National Association of Lift Makers

GEARLESS MACHINES BRAKE LEVER PIVOT PINS

GEARED MACHINE BRAKE SOLENOID
WASHER REPLACEMENT

BRAKE LEVER PIVOT PINS ON EXPRESS LIFT COMPANY GEARLESS MACHINES

Figure 1 - Washer Identification

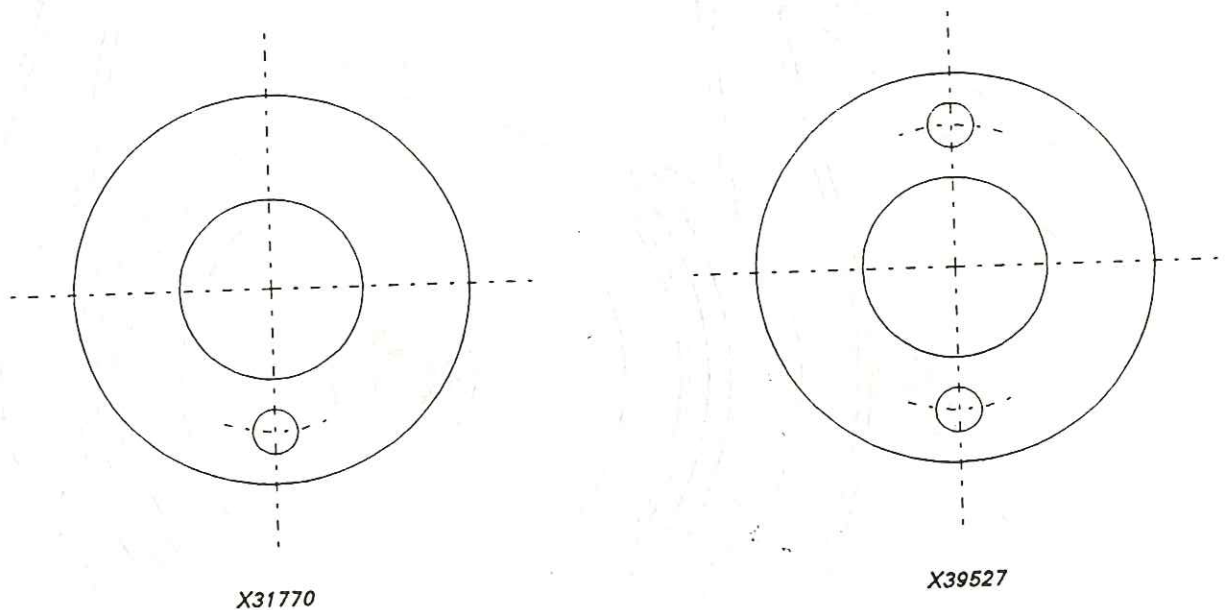
3.1 Disintegration of resilient stop washer inside brake solenoid causing operation of the brake to be retarded. (A batch of bought in stop washers have been supplied to an incorrect grade. These perish after prolonged contact with oil or grease).

4.1 Replace stop washer X31770 with a new washer X39527 manufactured from Nitrile rubber as follows:

4.2 Washers are identified as figure 1.

FIGURE 2 - BRAKE MECHANISM

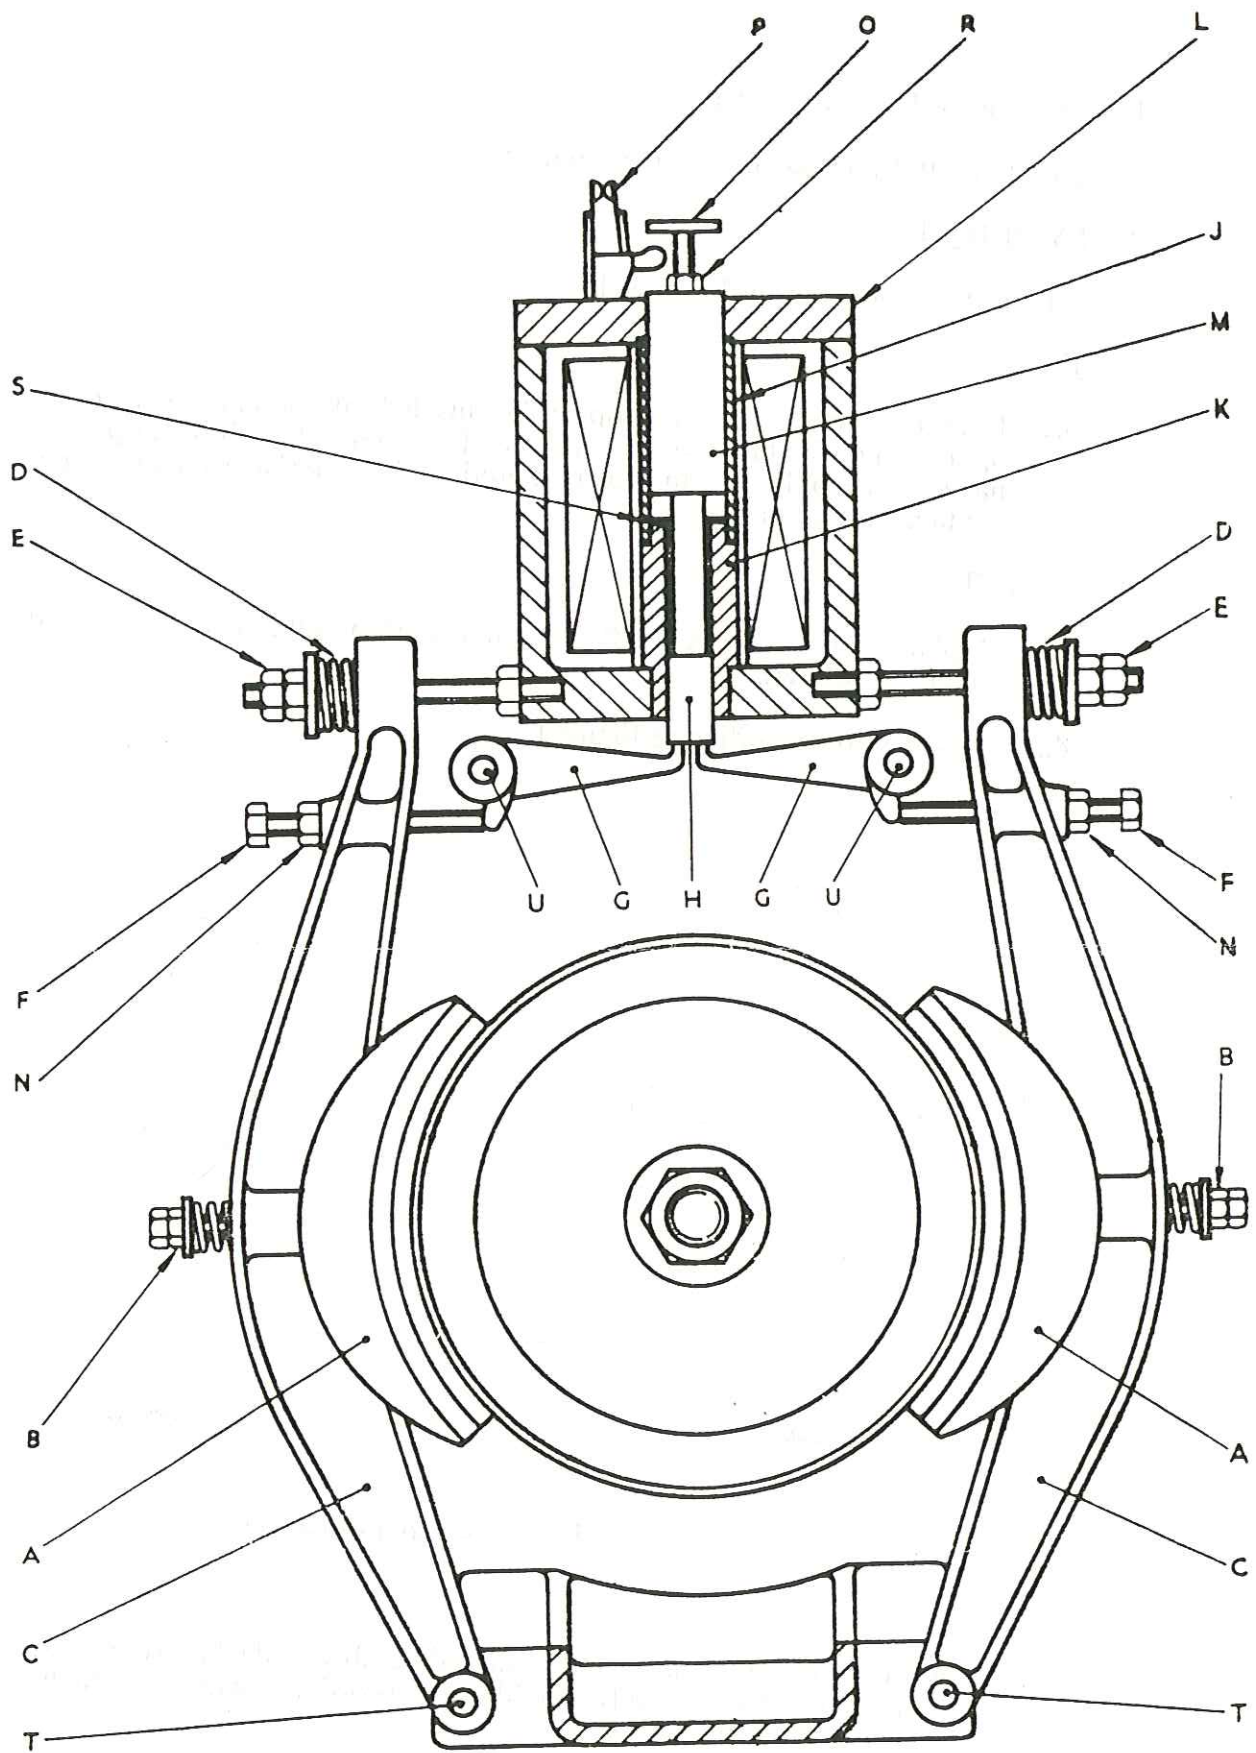
4.3 Appropriate service procedures should be observed when re-assembling brake components. Re-assembly should be in accordance with the attached details.

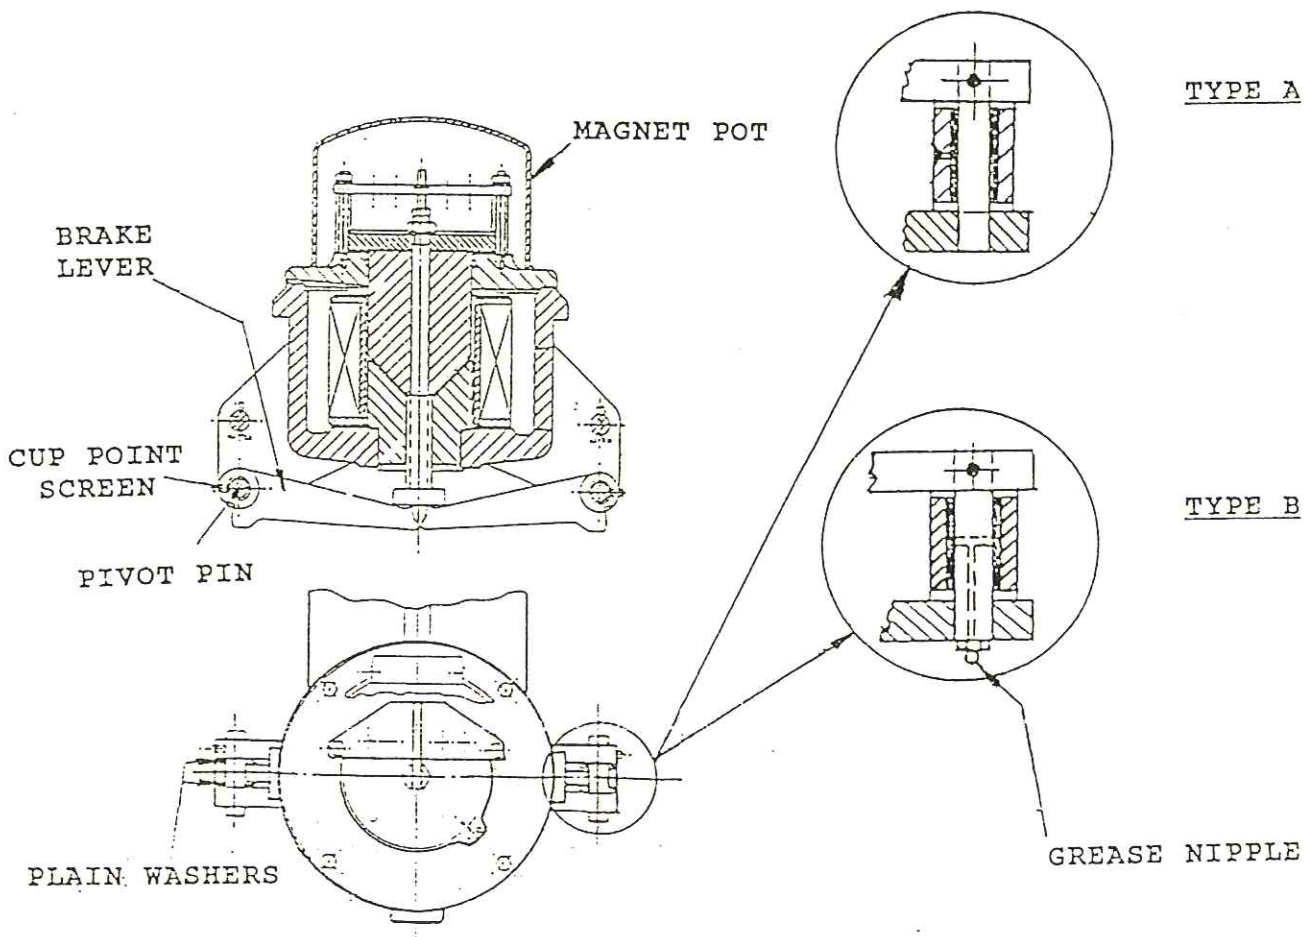
The lubrication of the brake pivot pins on early designs of Express Lift gearless machines has been found to be limited in some instances. Lubrication of these pivot pins can be improved by the fitting of the latest design which incorporates cross holes and a grease nipple in the end of the pin.

We recommend that the brake lever arms are inspected at the next routine service visit and any gearless machines with the earlier design (Type A) are changed to the latest design (Type B).

Details and parts for this change can be obtained from Lift Components Ltd.
